ADDENDUM NO. 1

CITY OF ROLLA
TAXIWAY A RECONSTRUCTION AND TAXIWAY CONNECTOR REHABILITATION
at
ROLLA NATIONAL AIRPORT (VIH)
VICHY, MO

MoDOT Project # 23-056A-1

ADDENDUM NO. 1

MoDOT PROJ. NO. 23-056A-1	WOOLPERT PROJ. NO. 10016991.00	SHEET NAME C102
		SHEET NO. 22 of 54

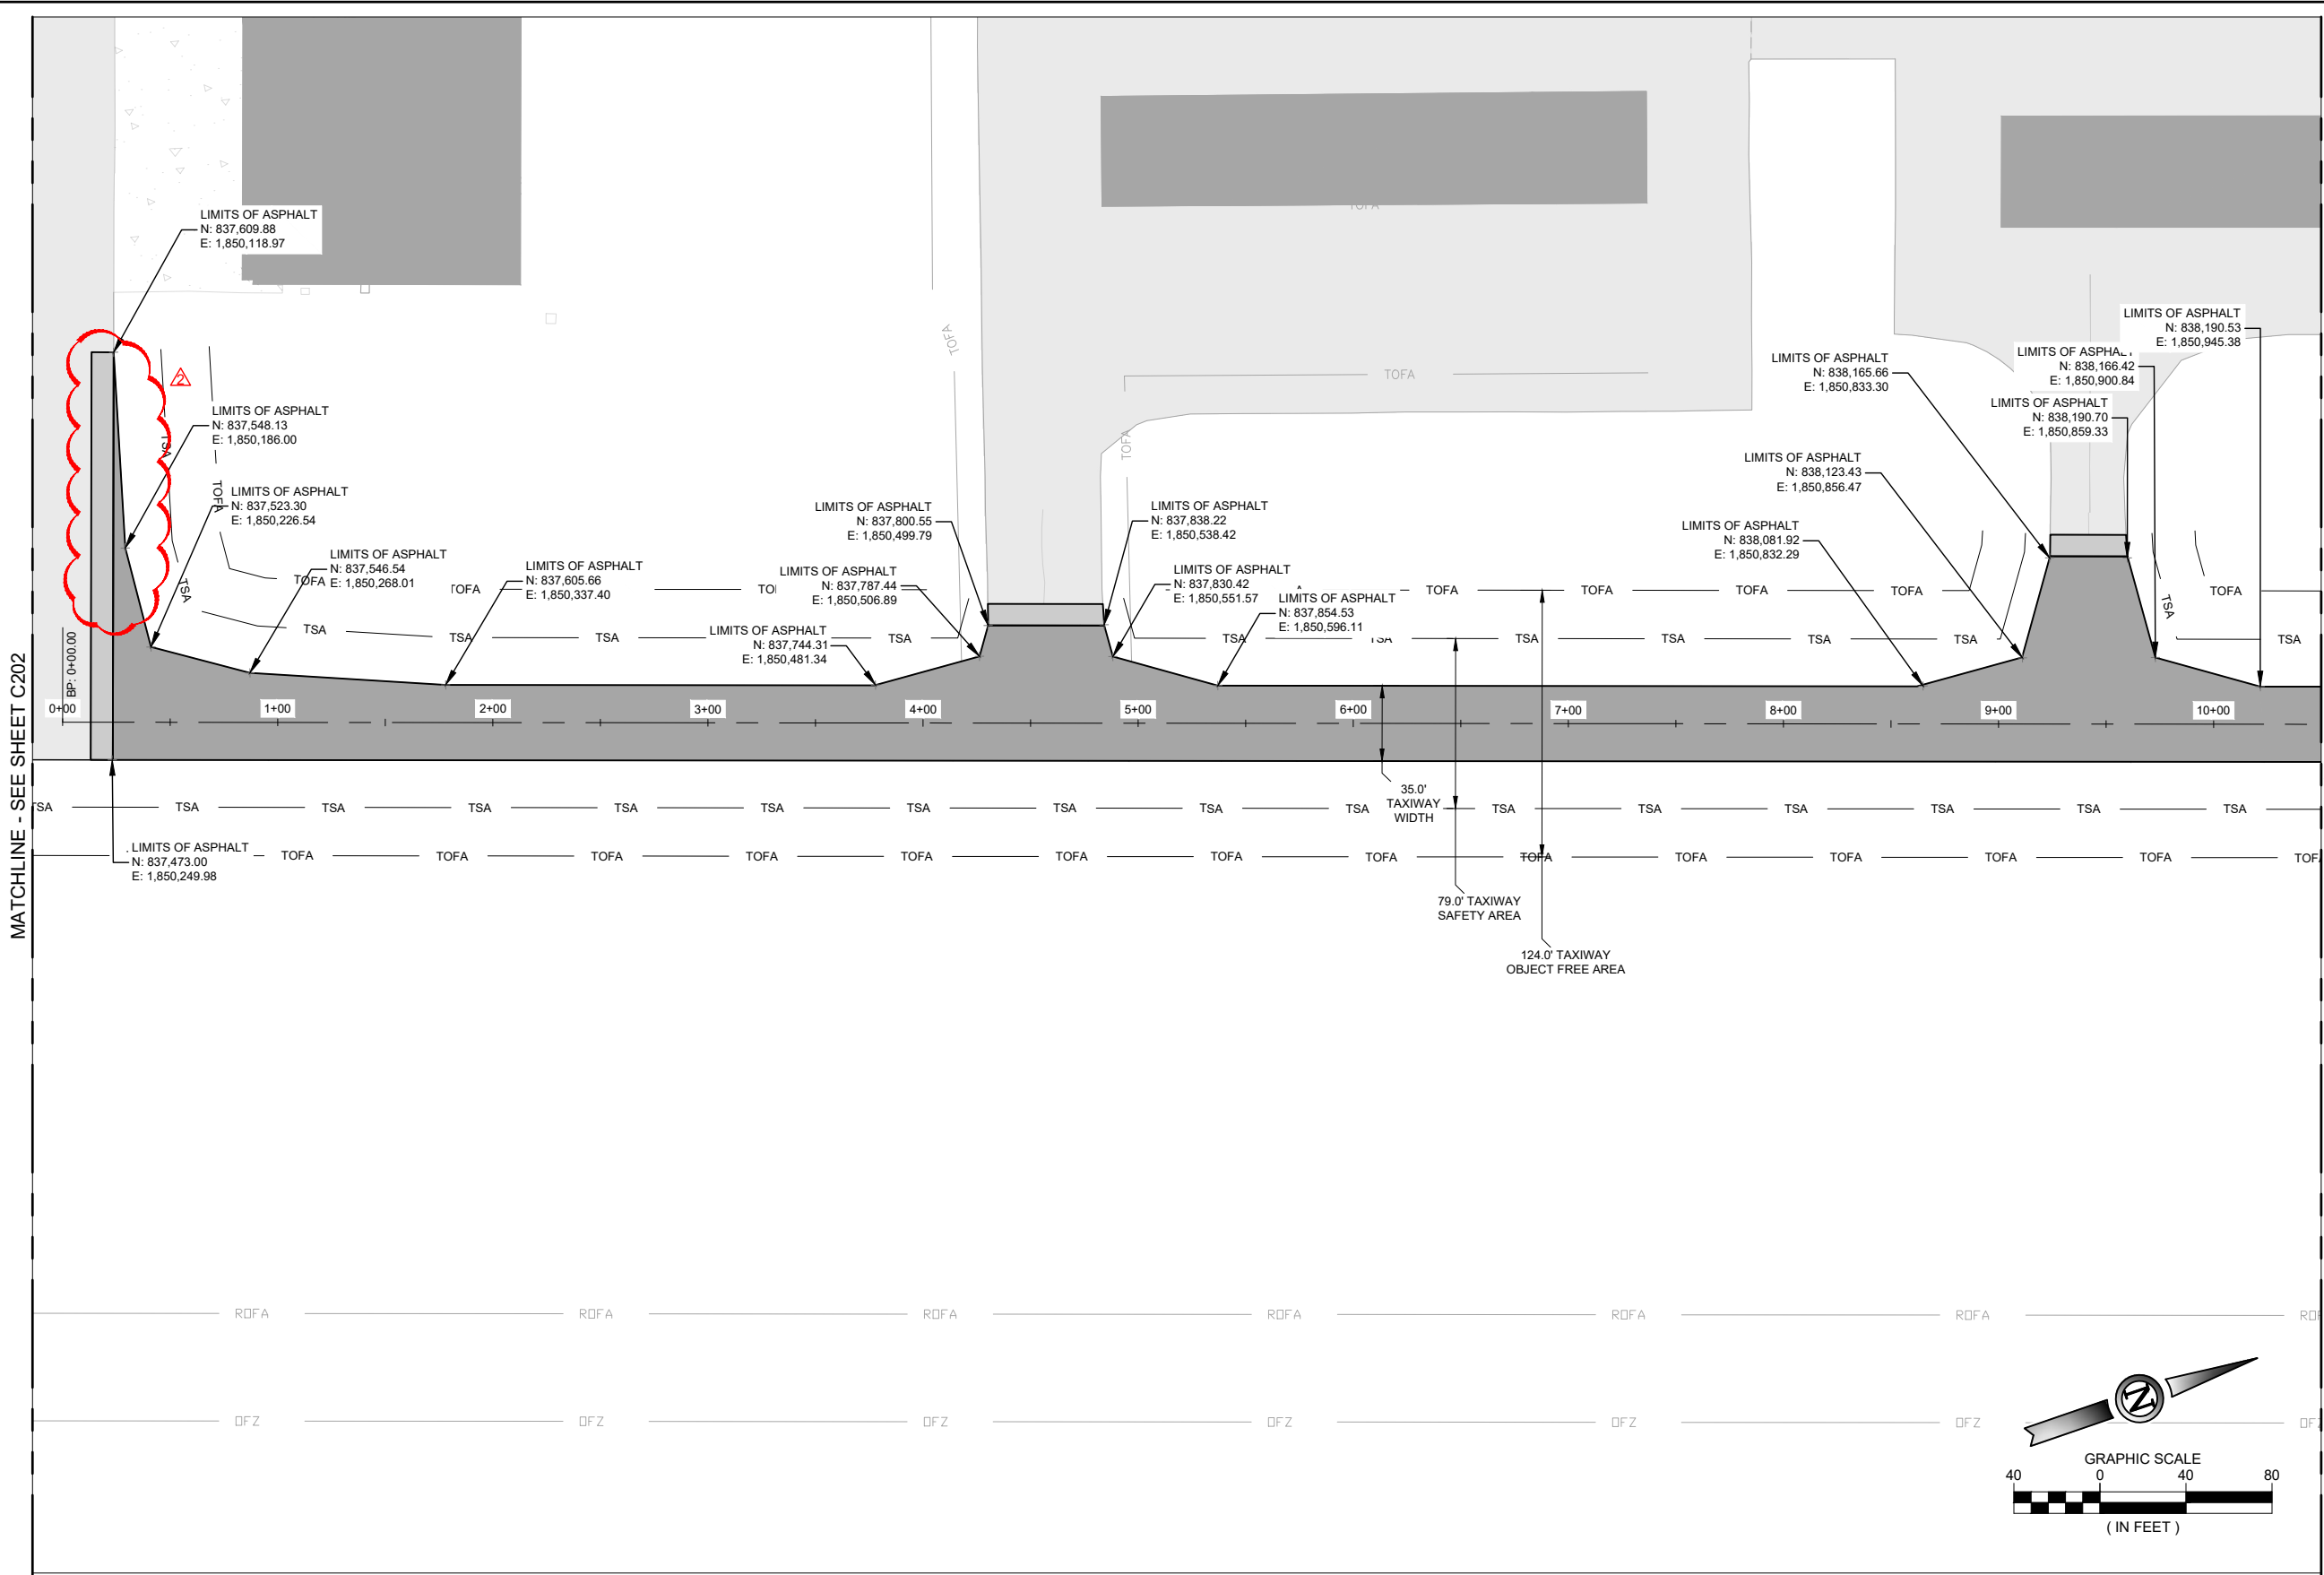
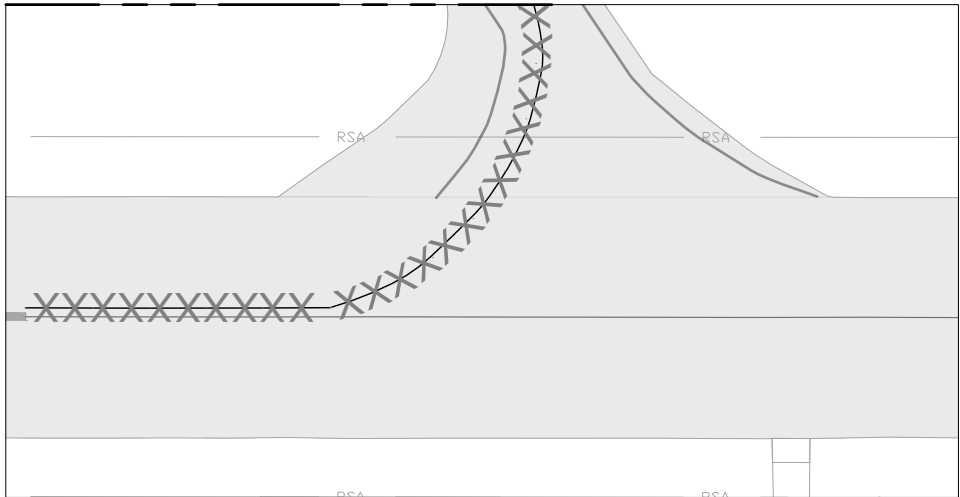
Revision: Added temporary removal of markings leading to closed areas.

Revision: Added viewport for paint obliteration/cover of runway lead-in line from Runway 4/22 to Taxiway A.

Justification: A viewport and matchline were added to clearly show the obliteration or covering of the runway lead-in line for construction purposes.

A TAXIWAY A PAVEMENT SECTION (NORTH - SOUTH)
 NTS
 NOTE: TAXIWAY A OVERBUILD WIDTH IS 1'

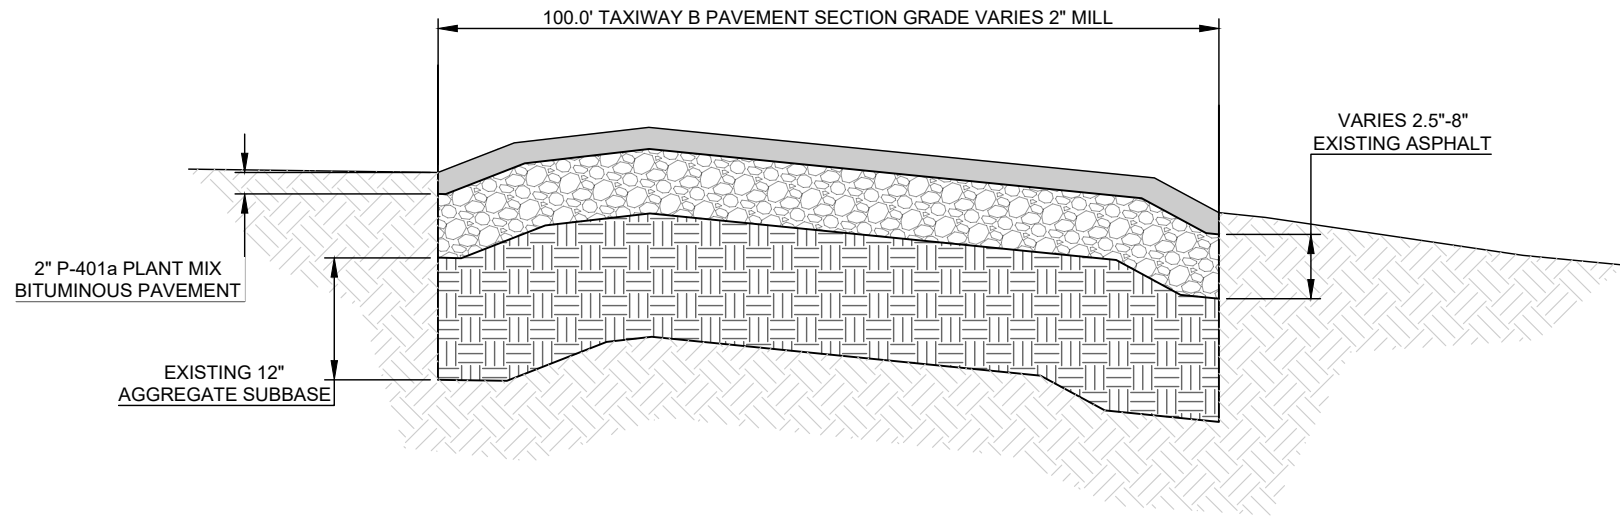
Revision: Slope labels added to detail A Taxiway A Pavement Section (North-South)

Revision: Updated Cement Treated Subgrade (CTS) item on detail A Taxiway A Pavement Section (North-South)

Revision: Note added to detail A Taxiway A Pavement Section (North-South)

Justification: This is to clarify the width of overbuild that is needed for the pavement section.

GRADING AND SPOT ELEVATION PLAN
TAXIWAY A (STA. 00+00 - 05+00)

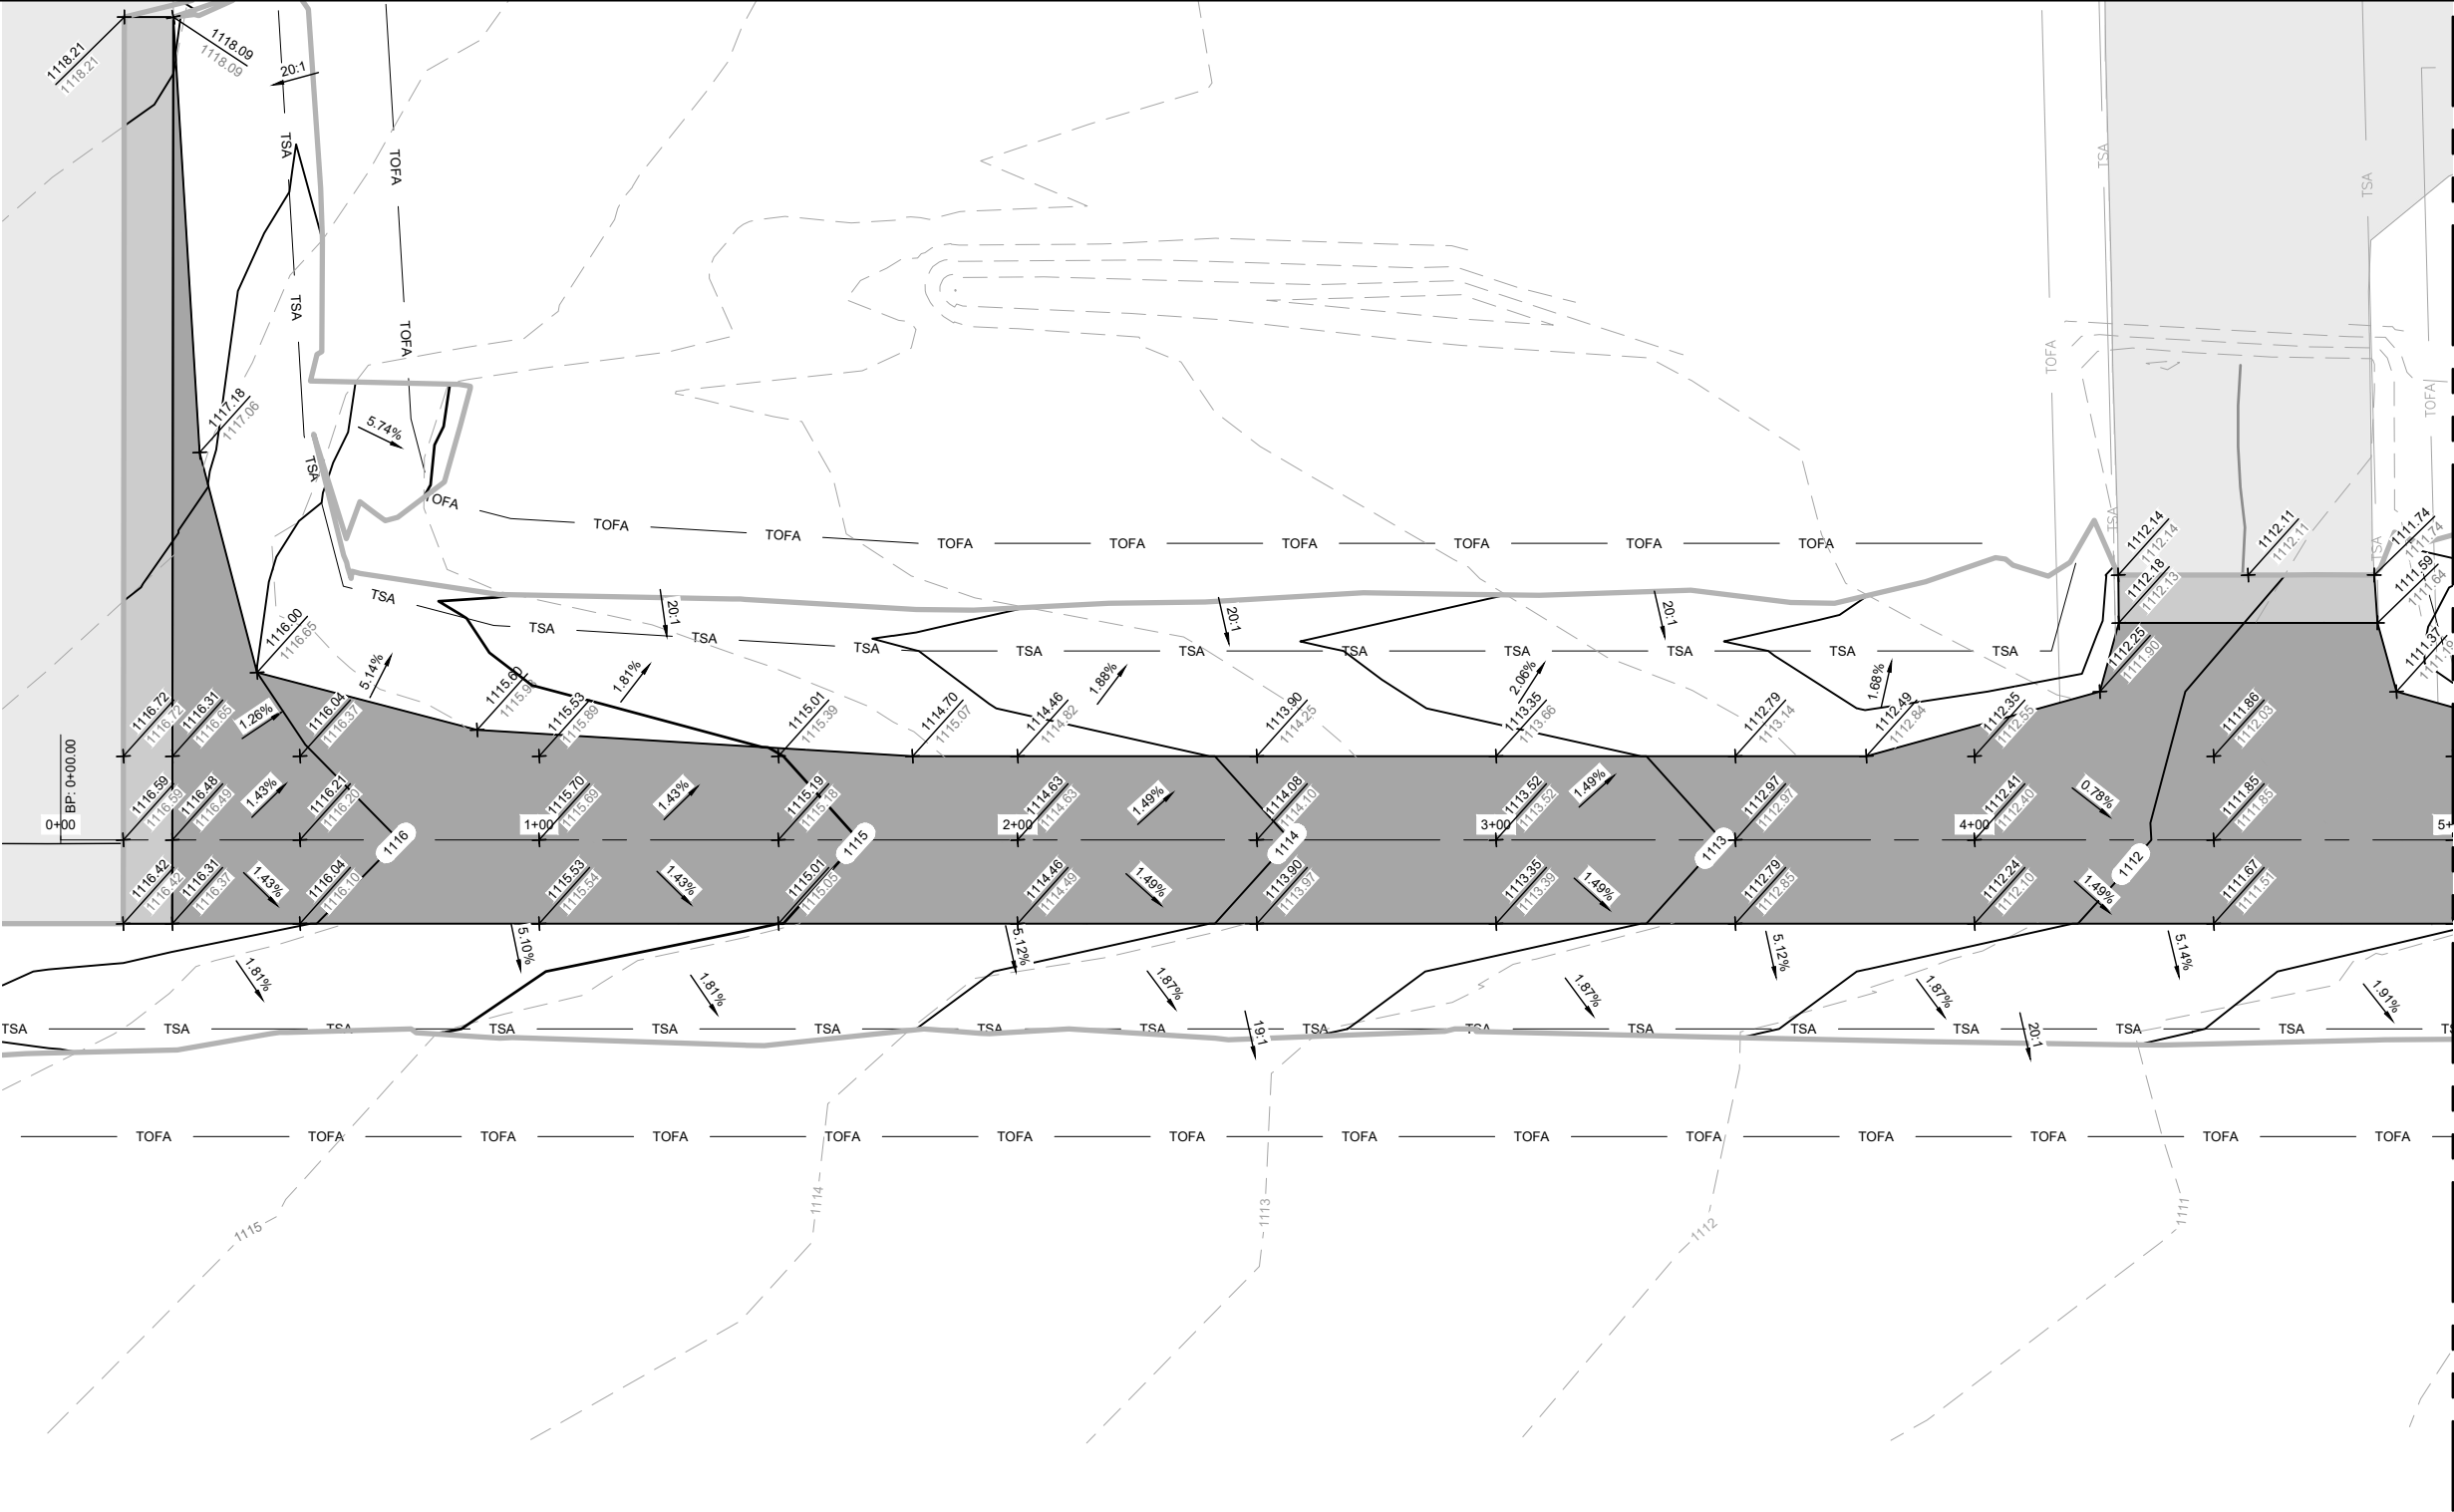
Revision: Added spot elevations every 50 feet.
